Federal Motor Vehicle Safety Standards; Bus Emergency Exits and Window Retention and Release

ACTION: Final rule.

SUMMARY: In this document, NHTSA amends the Federal Motor Vehicle Safety Standard on bus emergency exits and window retention and release to reduce the likelihood that wheelchair securement anchorages will be installed in locations that permit wheelchairs to be secured where they block access to emergency exit doors. Among other provisions, the final rule restricts, on new school buses, wheelchair securement anchorages from being placed in an area bounded by 305 mm (12 inches) forward and rearward of the center of the side emergency exit door aisle; and for the rear emergency exit door, an area bounded by a horizontal plane 1,145 mm (45 inches) above the bus floor and 305 mm (12 inches) forward of the bottom edge of the door opening (for school buses with a gross vehicle weight rating over 4,536 kg (10,000 lb)) and 150 mm (6 inches) forward of the bottom edge of the door opening (for school buses with a GVWR of 4,536 kg or less). Warning labels are specified for emergency exit doors and emergency exit windows not to block the exits.

Figure 6A. Side Emergency Exit – No Wheelchair Anchorages within the shaded region

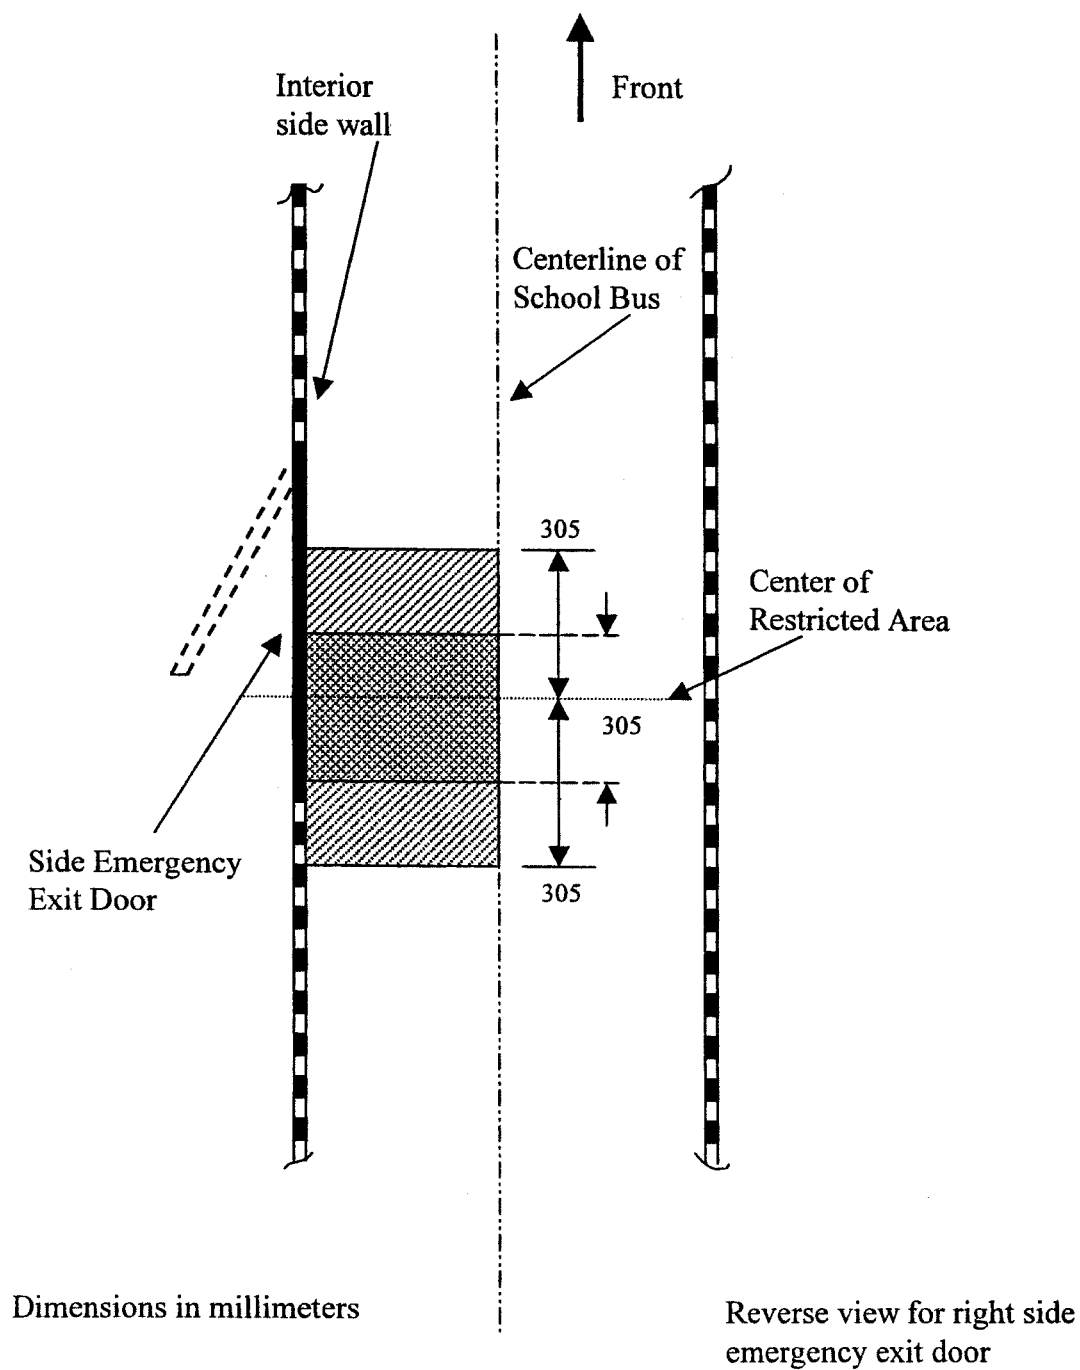
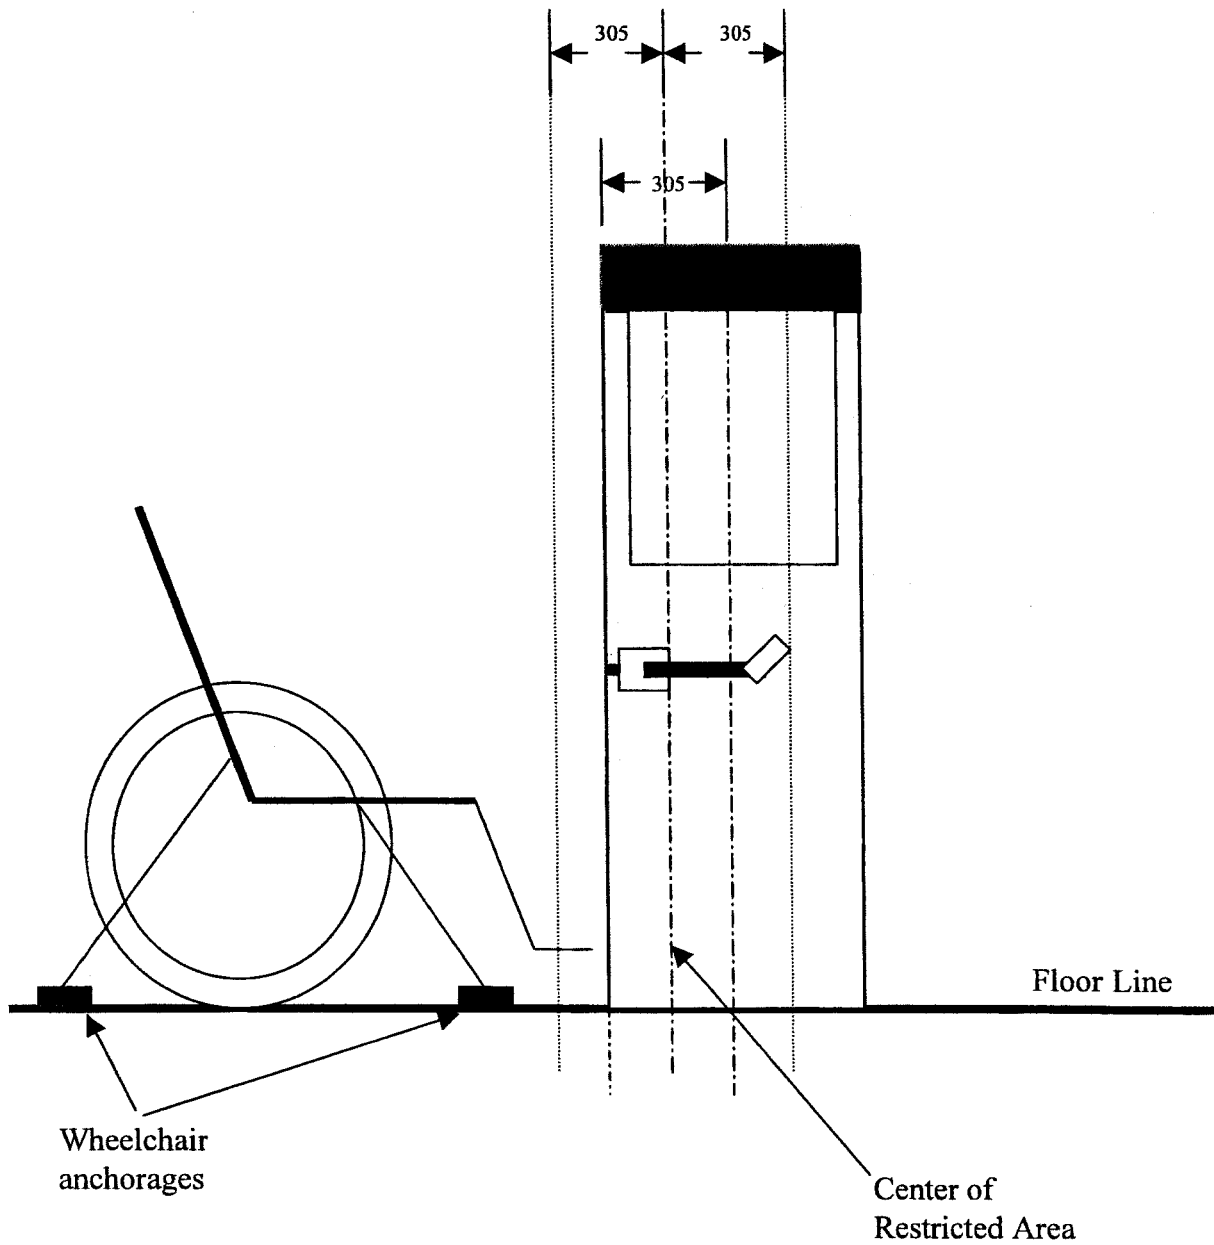
(a) In the case of side emergency exit doors, any portion of the wheelchair securement anchorage is within the space bounded by the interior side wall and emergency exit door opening, transverse vertical planes 305 mm (12 inches) forward and rearward of the center of any side emergency exit door restricted area, and a longitudinal vertical plane through the longitudinal centerline of the school bus, as shown in Figure 6A and Figure 6B.

Figure 6C. Rear Door Emergency Exit - No Wheelchair Anchorages within the shaded region

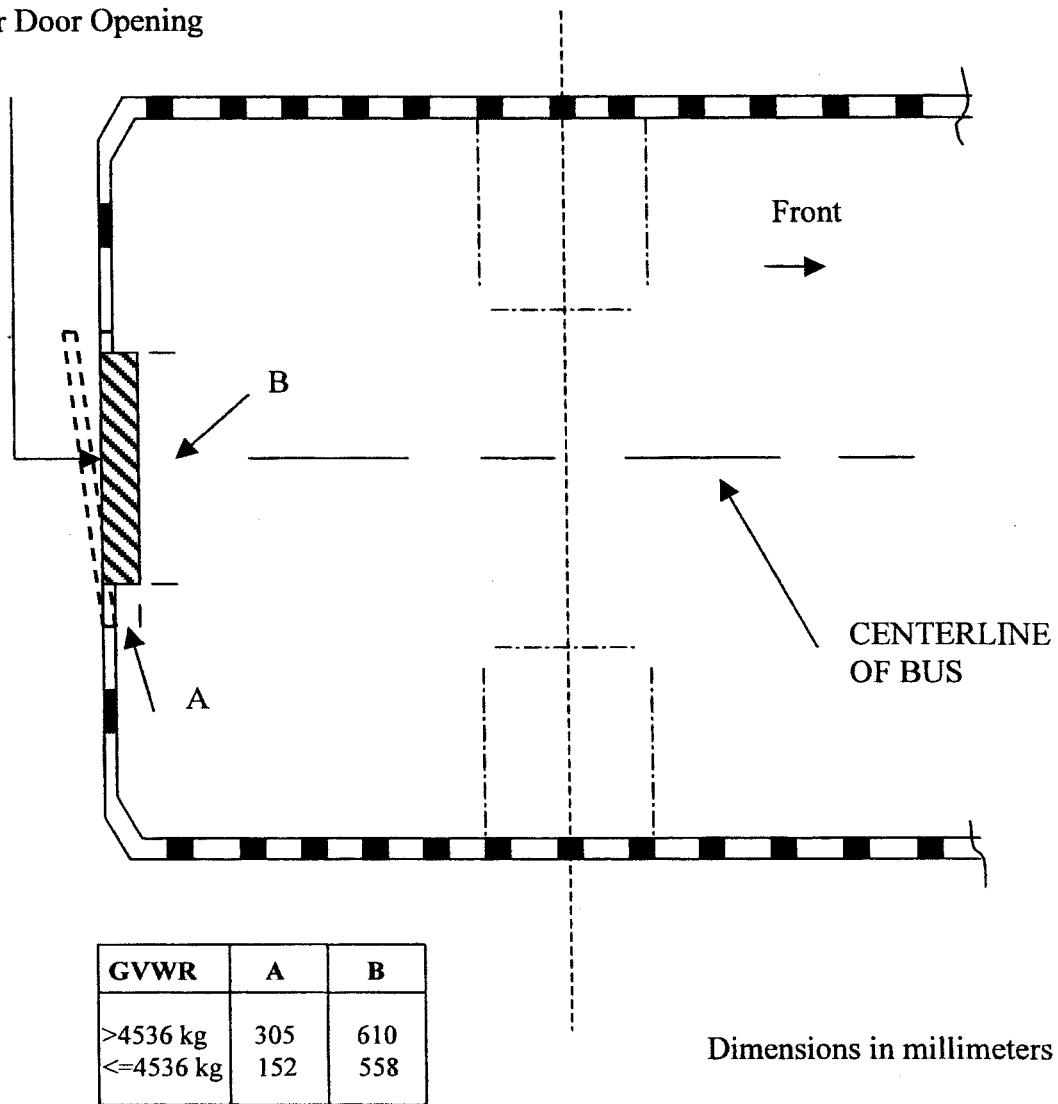
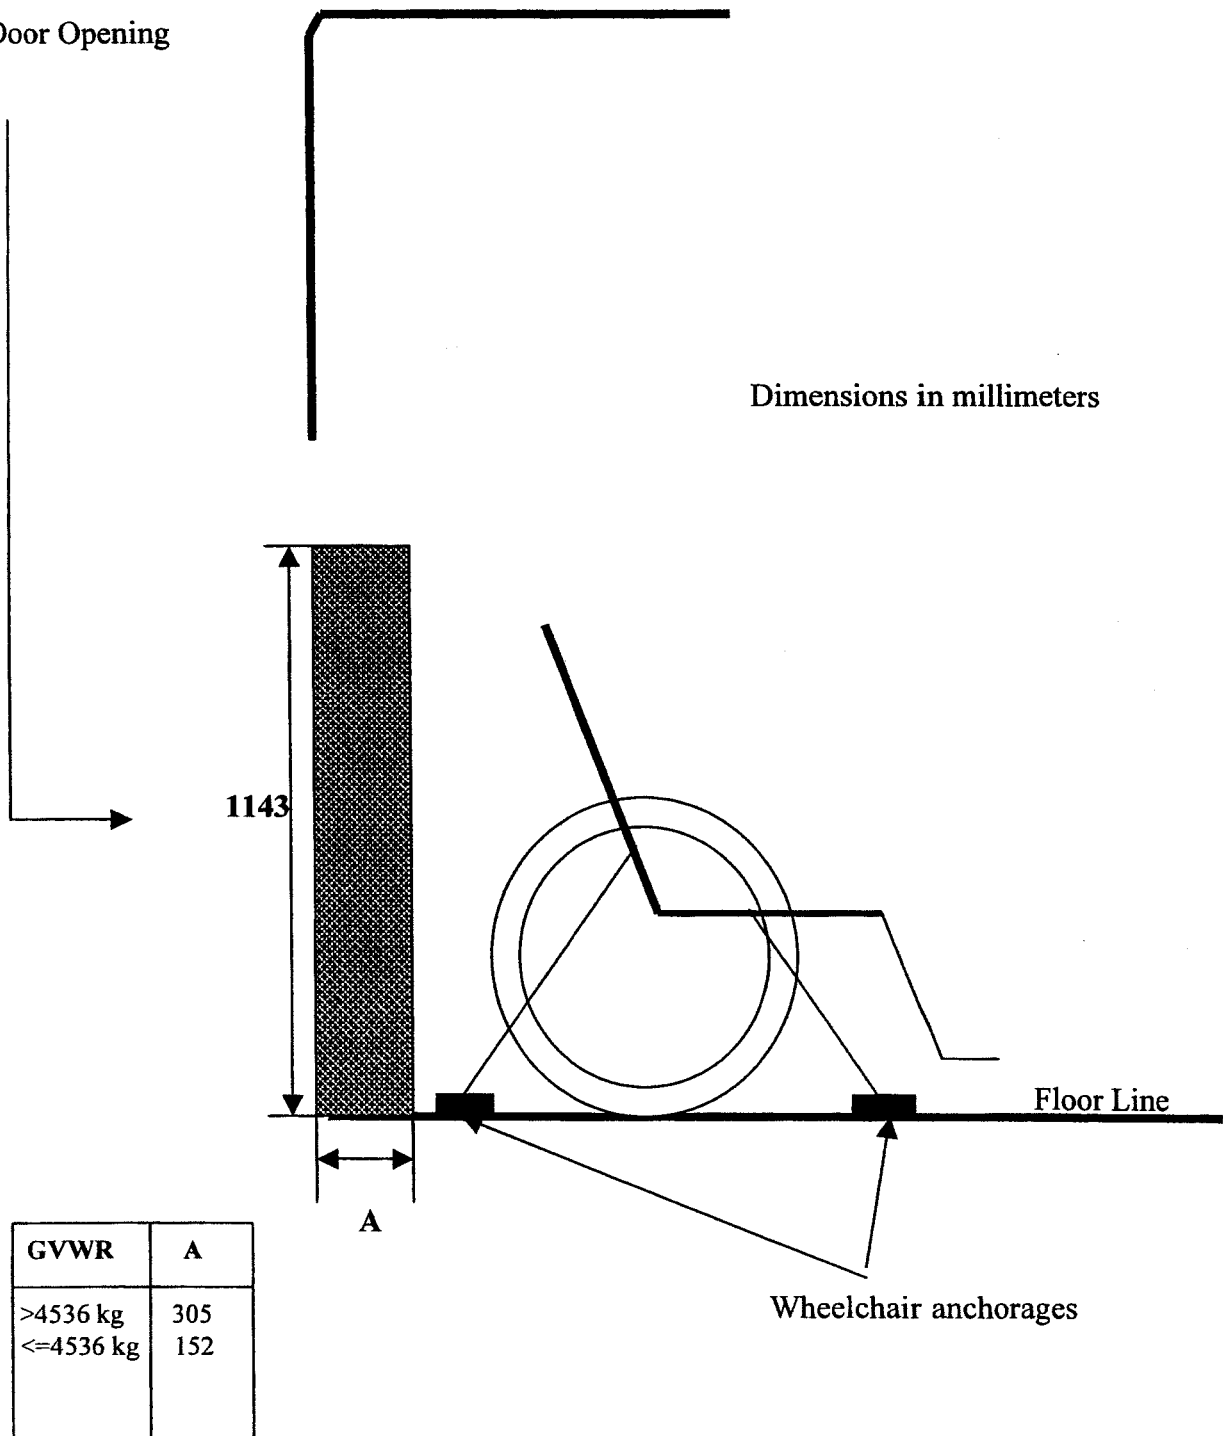
(b) In the case of rear emergency exit doors in school buses with a gross vehicle weight rating greater than 4,536 kg (10,000 lb), any portion of the wheelchair securement anchorage is within the space bounded by longitudinal vertical planes tangent to the left and right sides of the door opening, a transverse vertical plane 305 mm (12 inches) forward of the bottom edge of the door opening, and a horizontal plane 1,145 mm (45 inches) above the floor of the bus, as shown in Figure 6C and Figure 6D.

planes tangent to the left and right sides of the door opening, a transverse vertical plane 150 mm (6 inches) forward of the bottom edge of the door opening, and a horizontal plane 1,145 mm (45 inches) above the floor of the bus, as shown in Figure 6C and Figure 6D.
